Planning Commission Regular Meeting

BGV Parcel 6 Second
Resubdivision Plat

Subject:	Final Hearing for the Valor Heritage Subdivision (BGV Parcel 6) (Class A Subdivision Final Hearing, PL-2025-0148)
Proposal:	The applicant proposes to create a new subdivision of 14 single-family lots and associated easements off an extension of Timber Trail Road by replatting Parcel 6 of the remainder of Tract C, Peak 8 Subdivision. The approved April 9, 2024 Development Agreement between the Town and BGV and amended Peak 7 & 8 Master Plans contemplated the eventual subdivision of this parcel into 14 single-family residential lots.
Date:	September 12, 2025 (for meeting of September 16, 2025)
Project Manager:	Sarah Crump, AICP, Senior Planner
Property Owner:	P8E SFL, LLC
Applicant:	Graham Frank, P8E SFL, LLC (Breckenridge Grand Vacations)
Legal Description:	Parcel 6 Peak 8 Subdivision Filing No. 1 Proposed: Lots 1-14, Valor Heritage Subdivision
Site Area:	Total: 13.35 acres
Land Use District:	LUD 1 (allows 1 residential unit per 10 acres) Parcel 6 is subject to the Peak 7 and 8 Master Plan which supersedes the Land Use Guidelines regarding use and density and allows for 14 Single-Family Equivalents

C-110

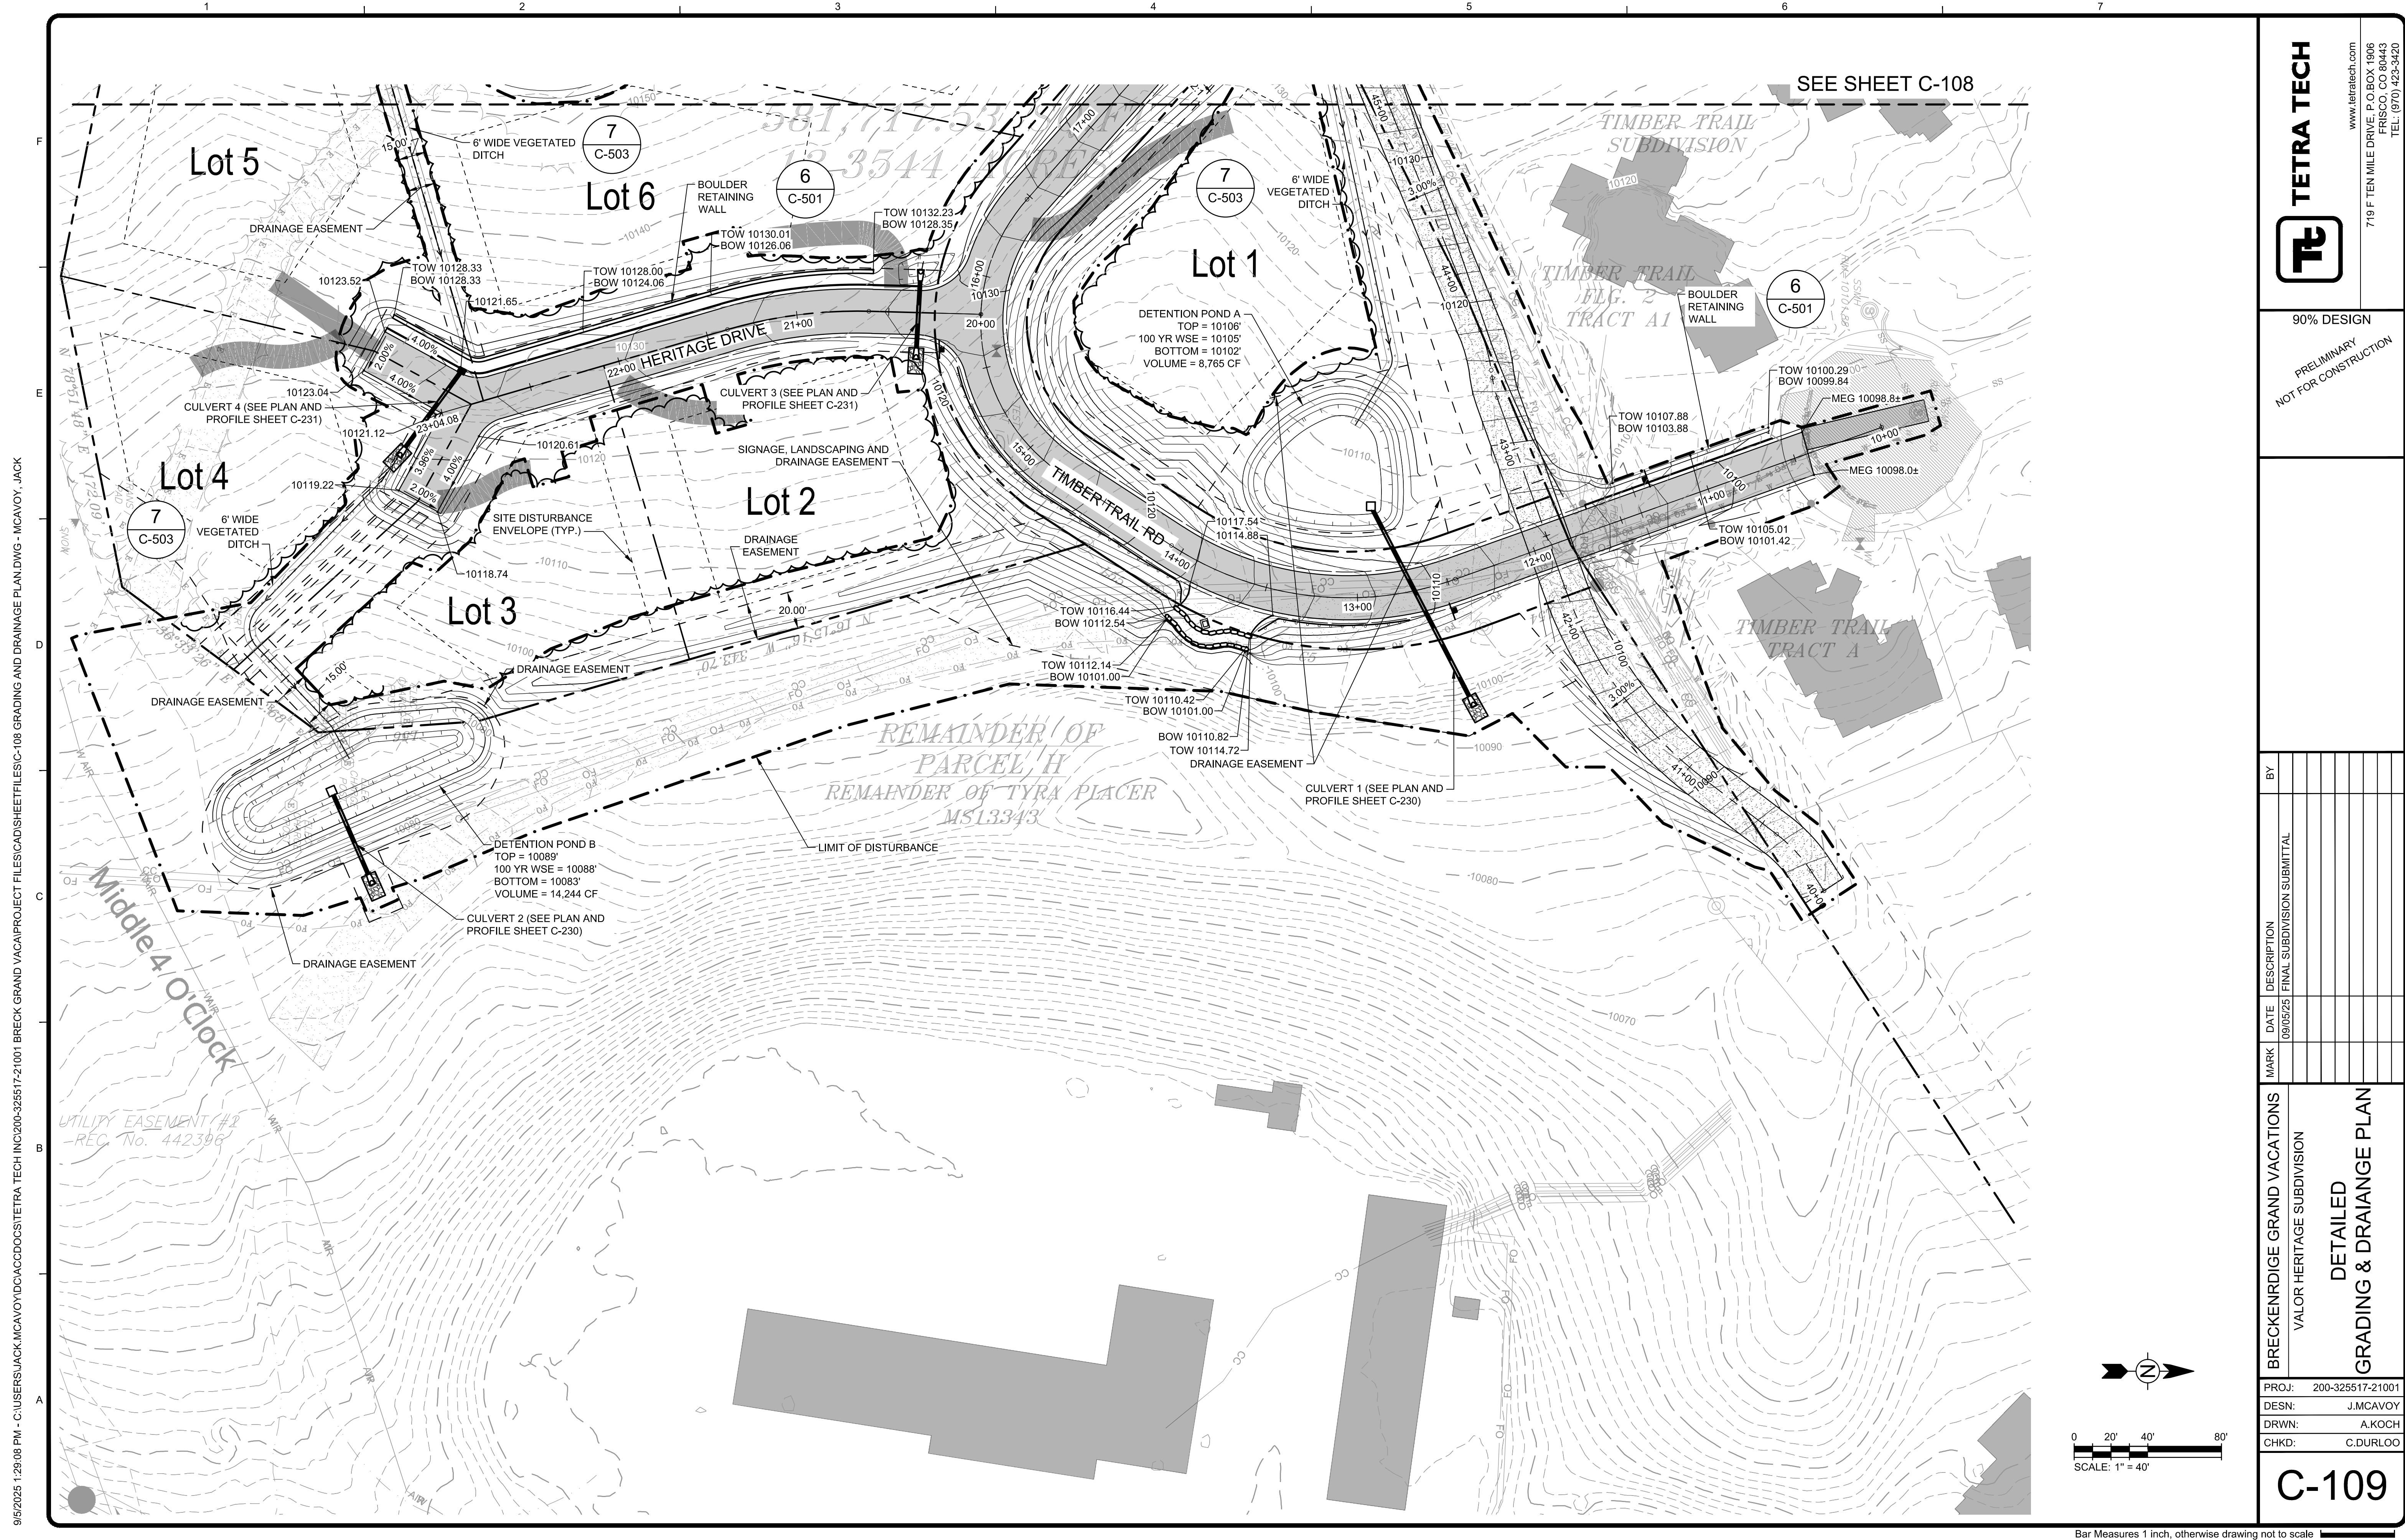
2. Drawing Sheet C-110

There was a slight overlap of the 100-year water surface elevation into the 10' wide snow storage and utility easement. The detention pond layout has been adjusted to remove it from the easement area.

LP-201

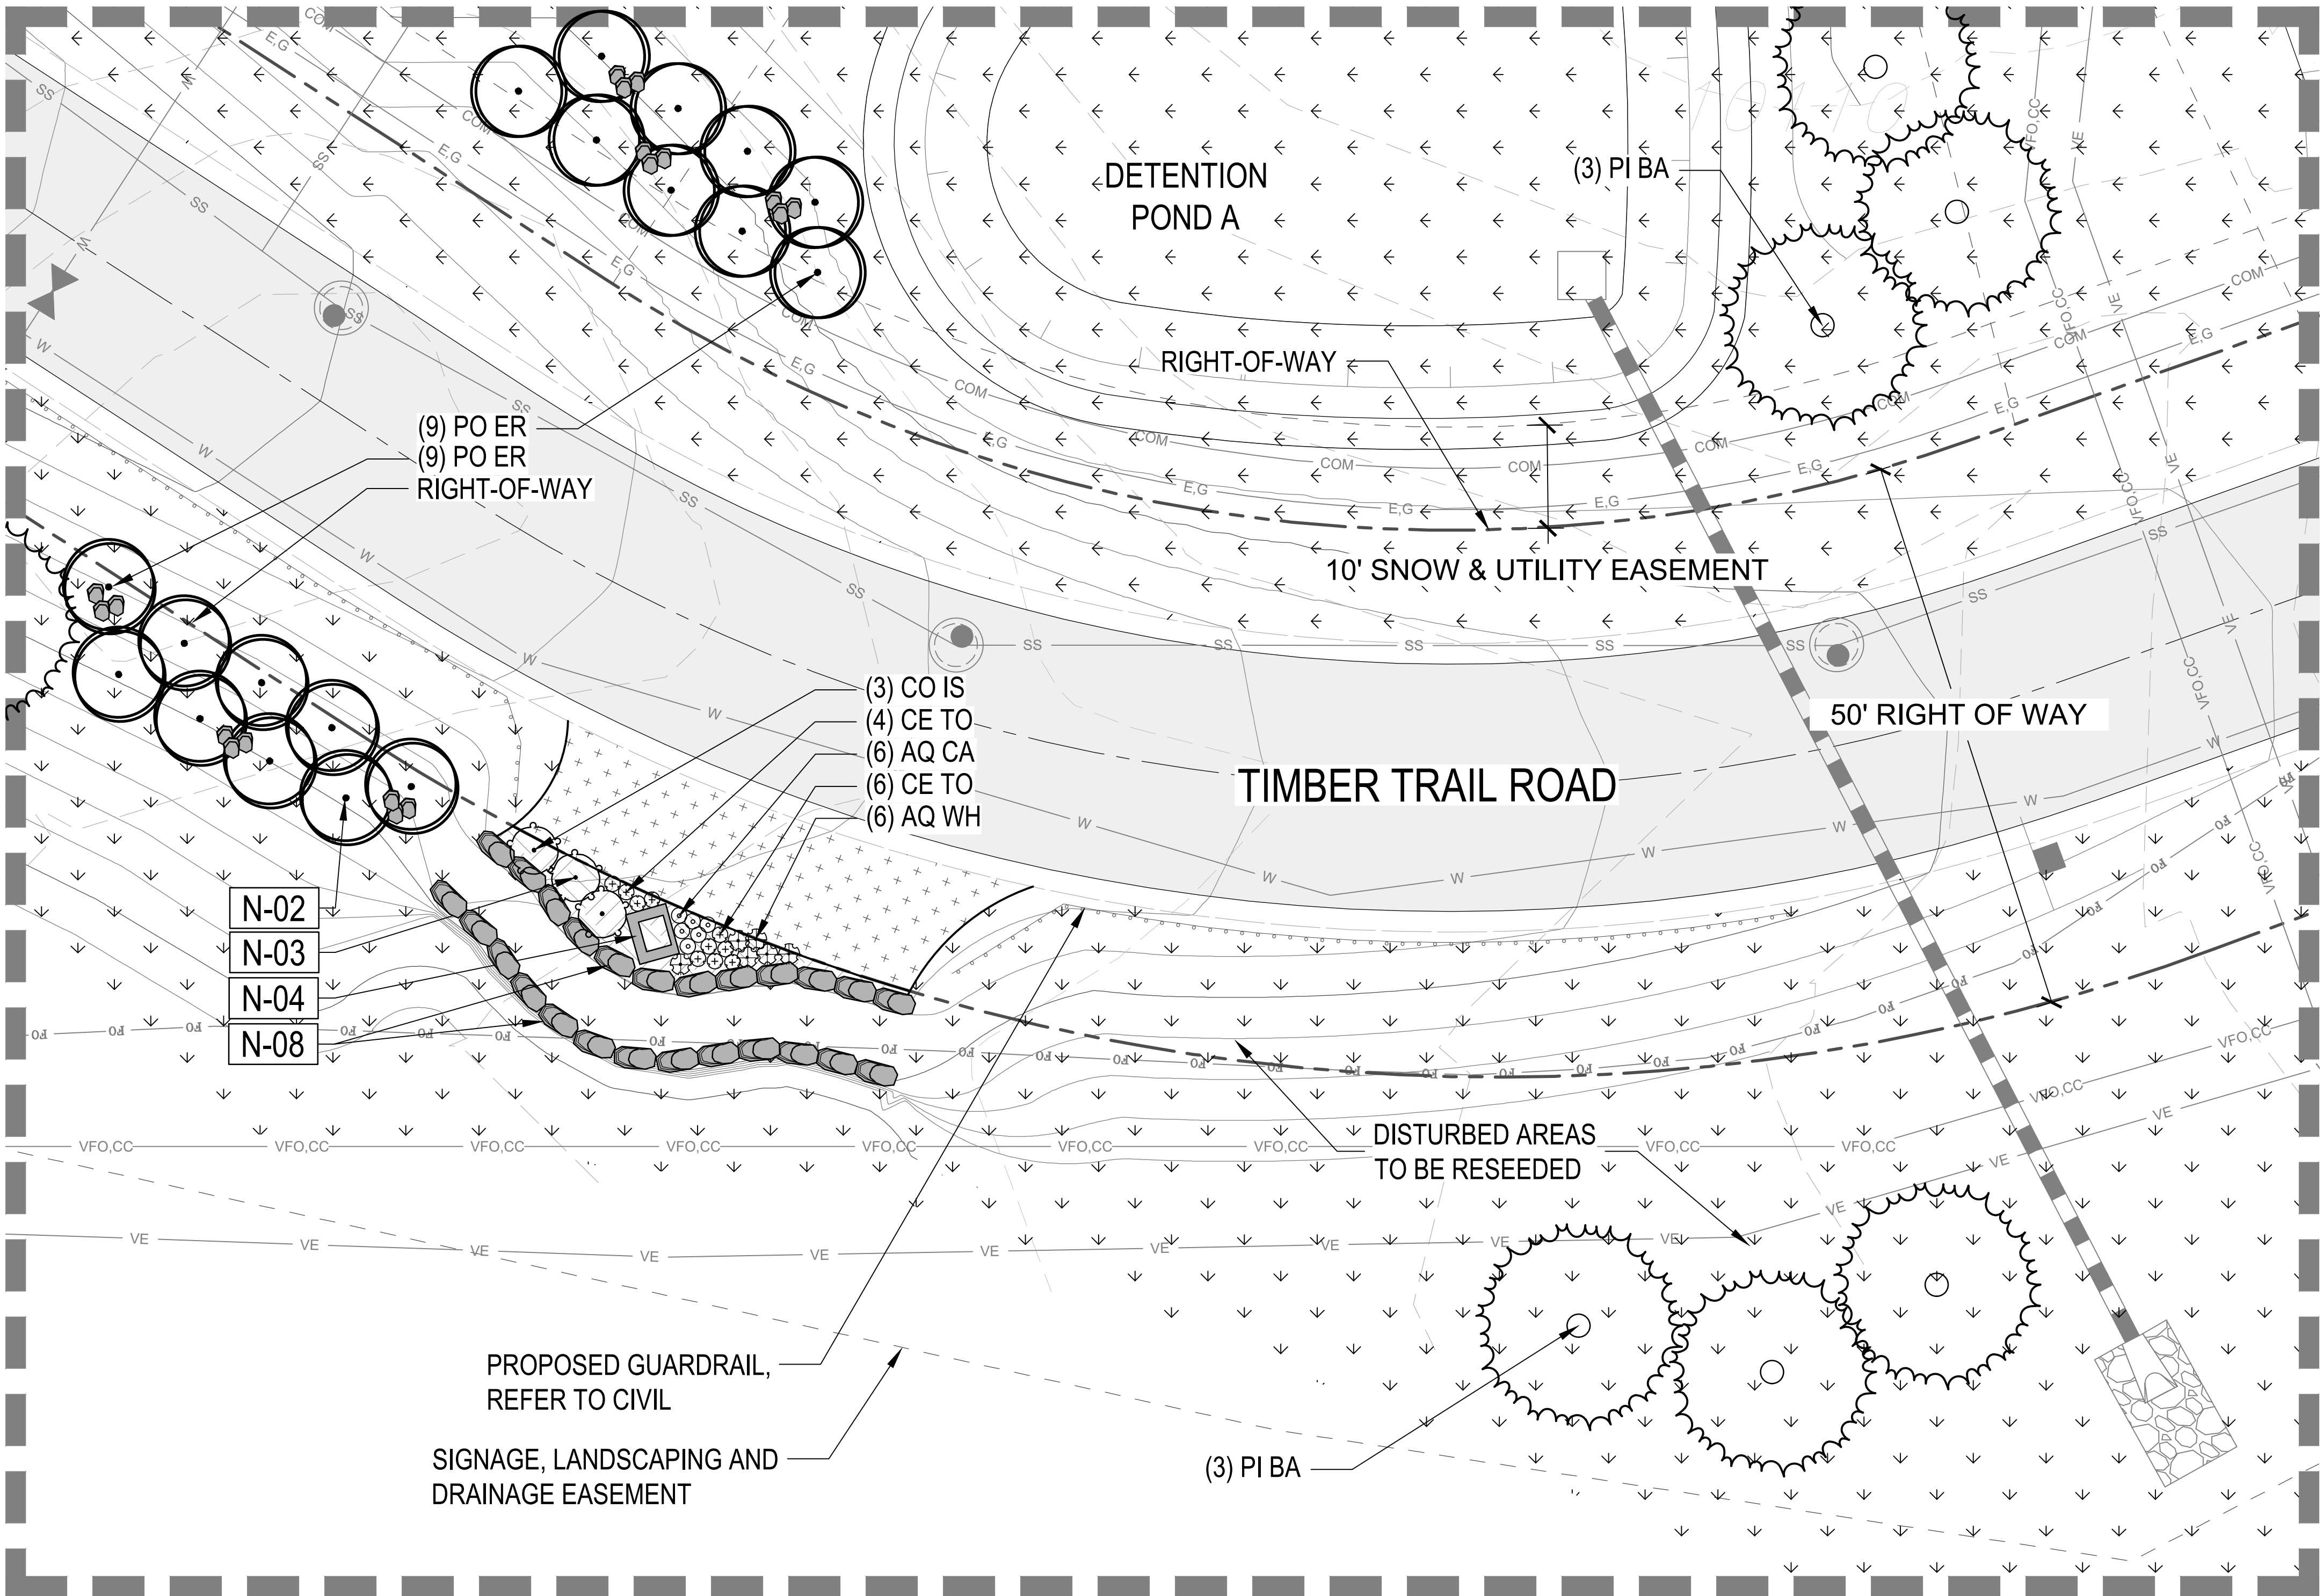
3.2. Verify that landscaping is not located in the snow storage easement along Timber Trail Road called out on the Plat drawings.

All landscape improvements are outside of the snow storage easements along the Timber Trail Road right-of-way (ROW). (Please refer to the snow storage plan on Sheet LP-201 of the landscape plan set for location verification. The snow storage easements linework has been better defined.)
